# Access Compliance Report

## Public Rights-of-Way

### (Curb Ramps)

Intersection ID: 10027413	Main Street: GOLF_LINKS_DR_N	Cross Street: N/A	Location: NW
ADA ID: B17FEFFCBB83	Ramp Type: BlendTrans1	Initial Pass/Fail: Fail	Overall Compliance: No
		Severity Score: 8.75

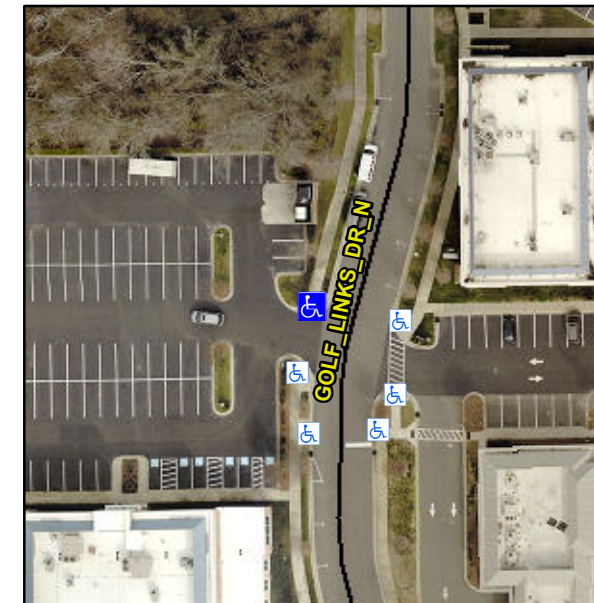
**Not Found, R304.5.1**

Compliance	Description	Data	Compliance	Description	Data
N/A	Ramp Length (in)	80.0	Yes	BlendTrans Slope (%)	3.6
No	Ramp Width (in)	45.0	Yes	BlendTrans XSlope (%)	0.7
N/A	Flare Type LT	N/A	N/A	Flare Type RT	N/A
N/A	Flare Slope LT (%)	N/A	N/A	Flare Slope RT (%)	N/A
N/A	Flare Traversable LT?	N/A	N/A	Flare Traversable RT?	N/A
N/A	Landing Length (in)	N/A	N/A	DWS Provided?	N/A
N/A	Landing Width (in)	N/A	N/A	DWS Contrast?	N/A
N/A	Landing Slope (%)	N/A	N/A	DWS Length (in)	N/A
N/A	Landing X Slope (%)	N/A	N/A	DWS Full Width?	N/A
N/A	Landing Curb? (Y/N)	N/A	N/A	DWS Offset (in)	N/A
N/A	Shared Landing?	N/A			
N/A	Gutter Ponding?	N/A	N/A	Gutter Slope (%)	N/A
N/A	Gutter Lip Ht (in)	N/A	N/A	Gutter X Slope (%)	N/A
N/A	Painted X Walk1?	No	N/A	Painted X Walk2?	No
	X Walk 1 Direction	To S		X Walk 2 Direction	To E
	X Walk 1 Width (in)	N/A		X Walk 2 Width (in)	N/A
	X Walk 1 Slope (%)	0.1		X Walk 2 Slope (%)	1.9
	X Walk 1 X Slope (%)	3.6		X Walk 2 X Slope (%)	0.6

N/A	Ramp inside XWalk1?	N/A	N/A	Ramp inside XWalk2?	N/A
	Road Slope (%)	1.7		Clear Space?	N/A
	Road X Slope (%)	3.5	N/A	Clear Space to XWalk (in)	N/A
N/A	Any Obstructions?	N/A	N/A	Storm Grate/Utility Hazard?	N/A
	Obstruction Type			Storm Grate/Utility Type	
		N/A			N/A
			Yes	Surface Condition? (G/P)	Good
			No	Curb Slope (%)	9.9

**Remove & Replace Curb Ramp With Two New Directional Ramps or Equivalent.**
